December 1, 2010

RE: P0389436
MARCO'S PIZZA SELA#1 SUITE 1
2349 EAST GAUSE BLVD
SUITE 1
SLIDELL, LA 70469

FLOOR PLAN

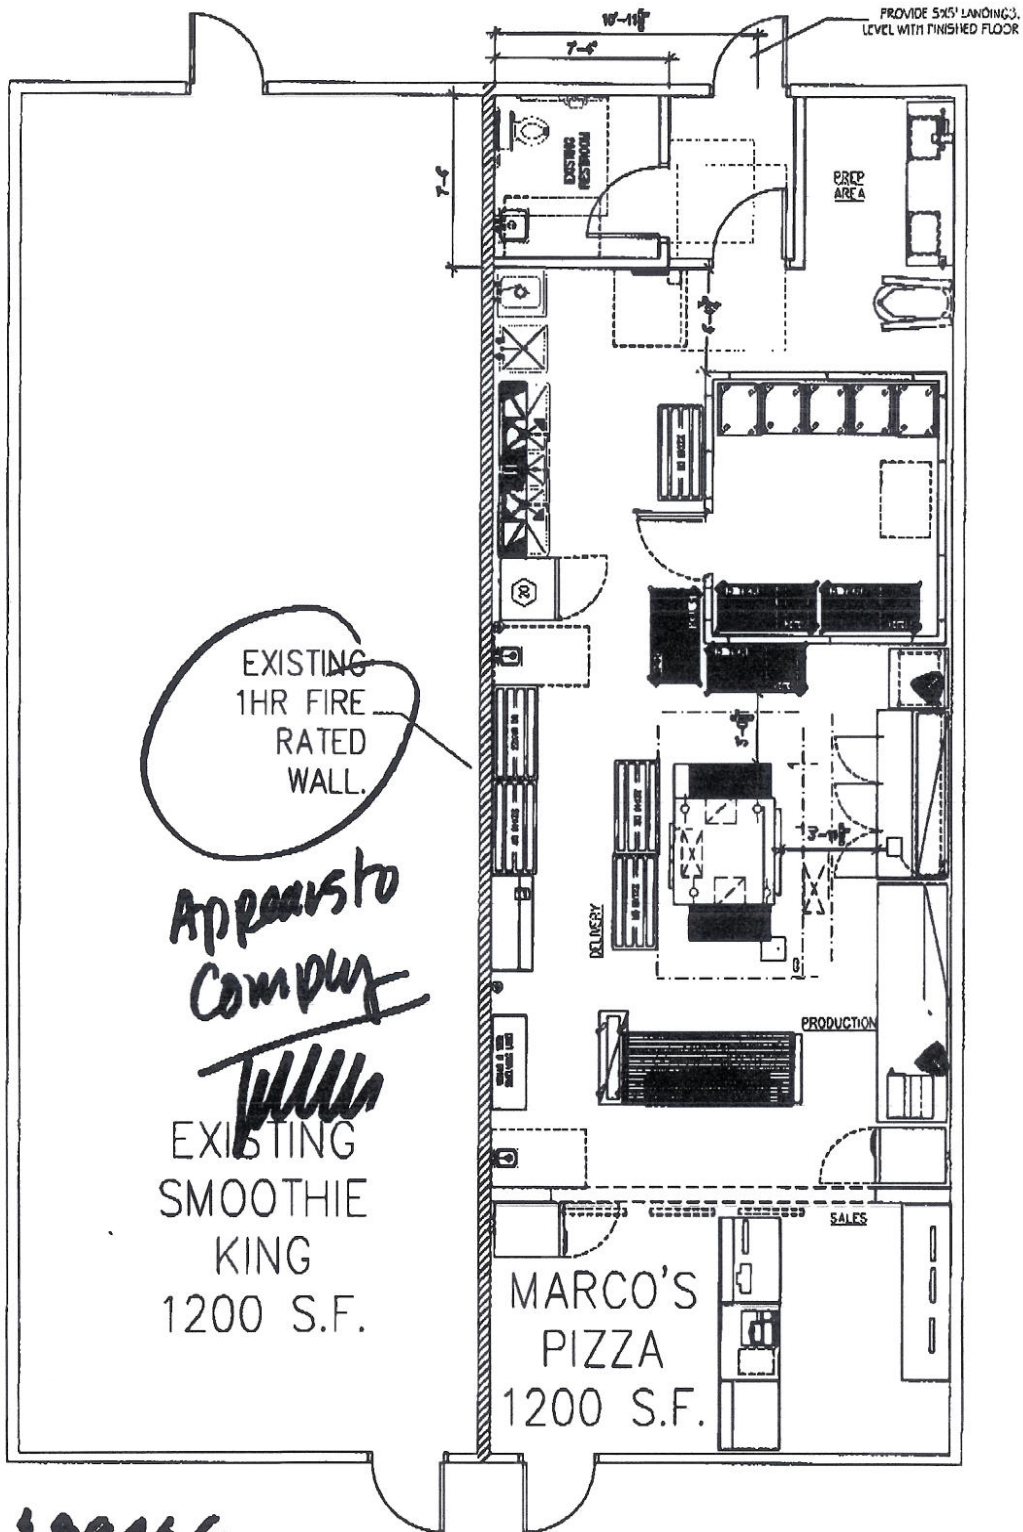
With regard to the above referenced project, the existing demising wall between Suite 1 and Suite 2 was incorrectly labeled on our construction drawings. The construction drawings showed this existing demising wall as an existing 2-hr rated wall. This wall should have been labeled as existing 1-hr. rated wall. Please see attached drawing.

The current tenant in Suite #2 is a Smoothie King restaurant, also the owner of the building; Smoothie King has the same square footage as the new Marco's Pizza, 1200 s.f. Both Smoothie King and Marco's Pizza would be the same occupancy, Assembly under 50 occupants - Mercantile. According to NFPA 101, table 6.1.14.4.1(b), there is no separation required between the same occupancies. Therefore a 1-hr. rated wall complies with the NFPA 101.

EXISTING
1HR FIRE
RATED
WALL.

Instructions have been provided to the contractor to maintain the existing 1-hr fire rating.

12/7/10
APPEARS TO COMPLY
JULIE LITTLE
#525
